ADDENDUM NUMBER 2 ON INVITATION TO BID ITB21DB-126

TITLE: 6ft Black Aluminum Picket Fence for Perimeter of Flavet Field

REVISED ATTACHMENT A

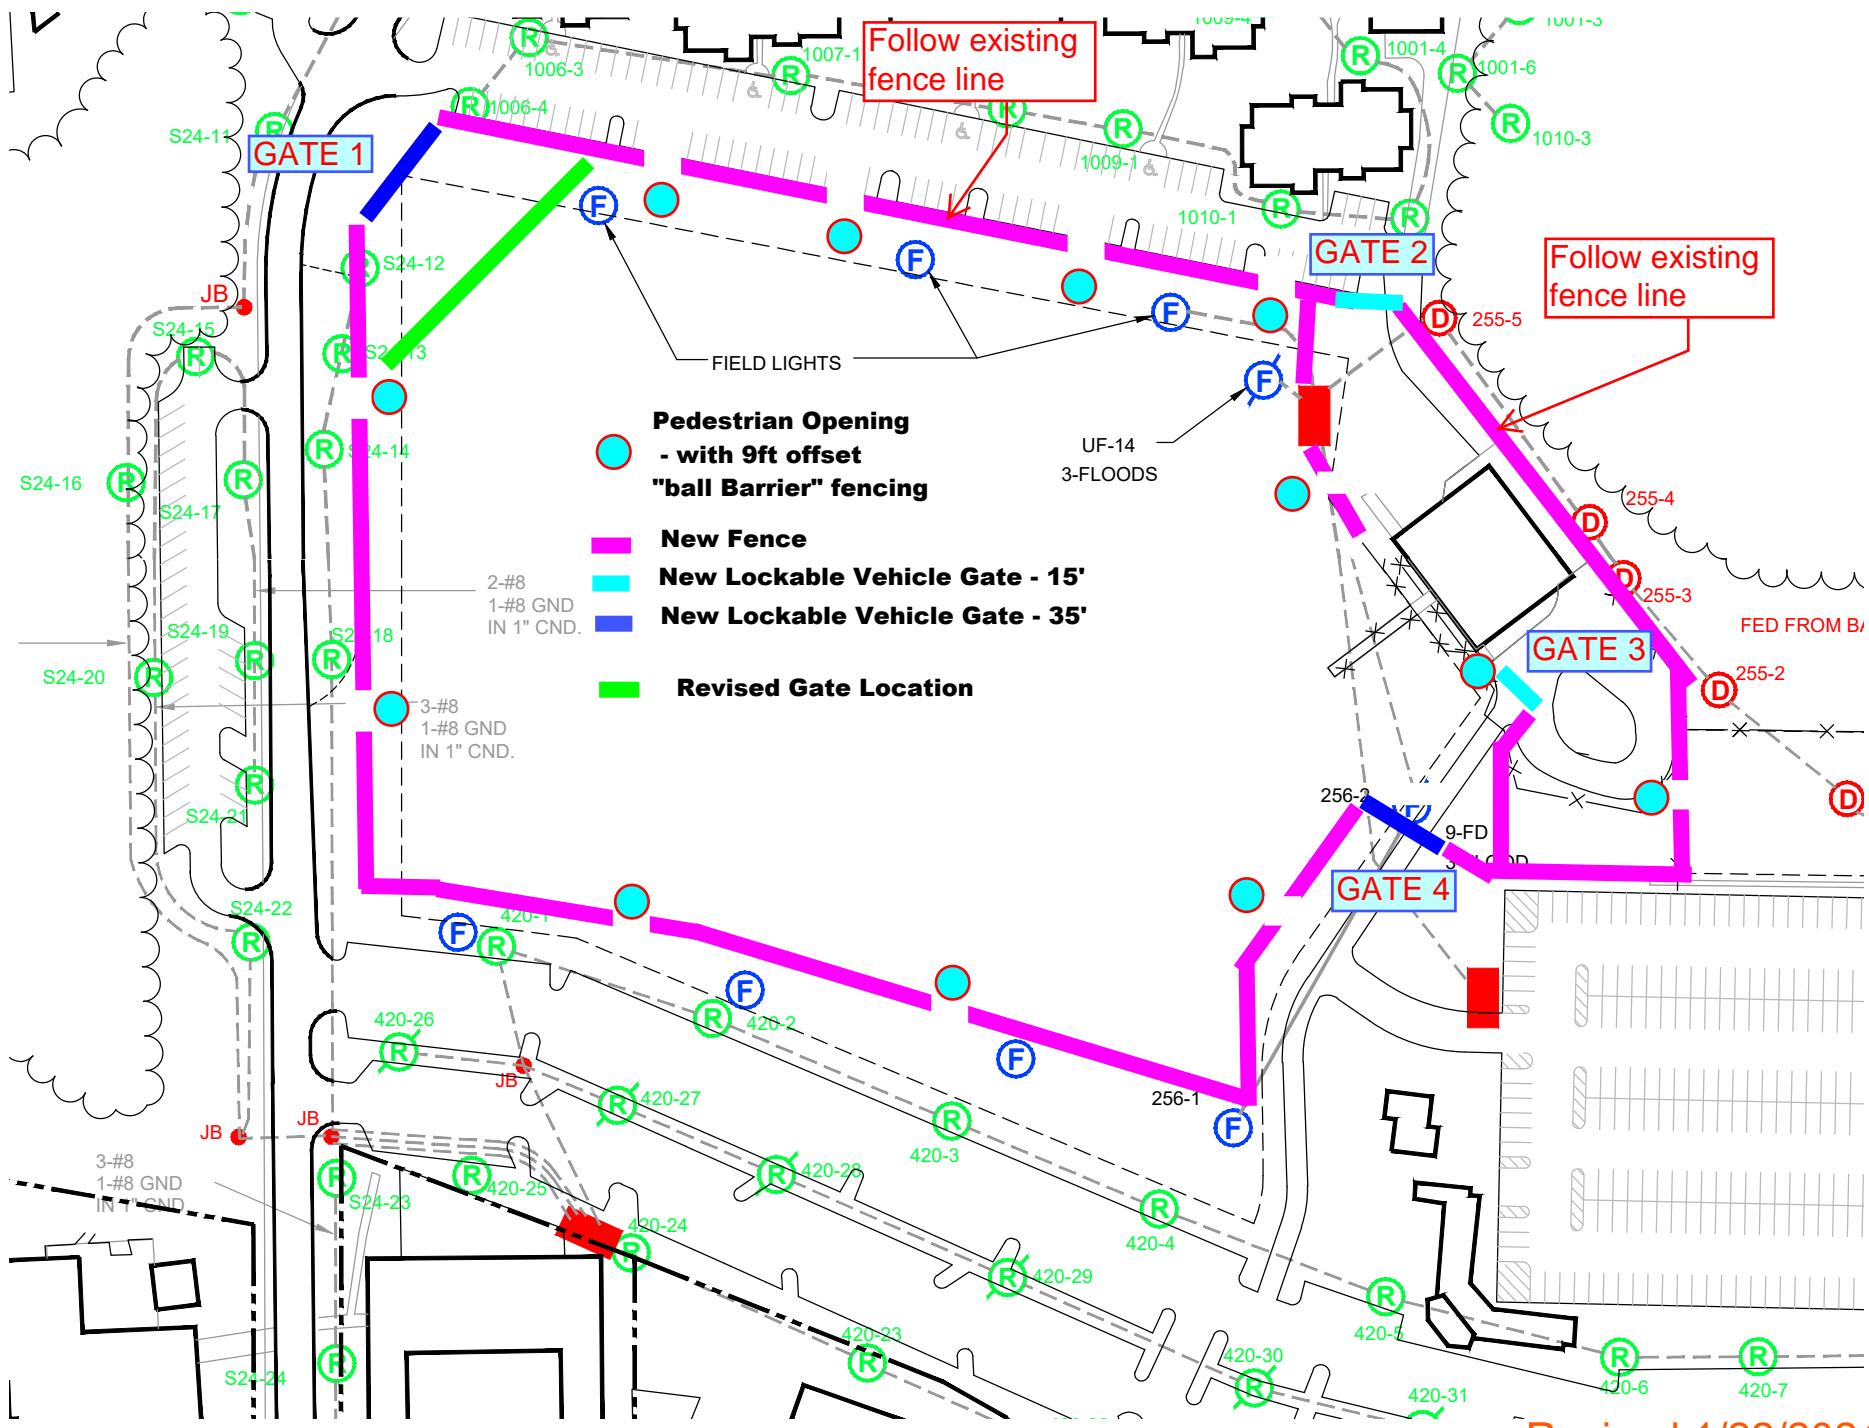
Q8. The gate on the Northwest corner of the property does not have enough room for a 36' Single or Double roller gate. Can a swing gate be used instead?

Q11. Can you clarify which gates are eliminated or changed to ball barrier entrances?

A8. Gate location has been revised. Roller gate is required. Posts need to be 6" X 6" X .250". See Attachment A, Revised 01/22/2021.

A11. See revised Attachment A included in this addendum for pedestrian openings, these are the ball barrier entrances. The two pedestrian openings located on either side of the stage do not require ball barrier gates.
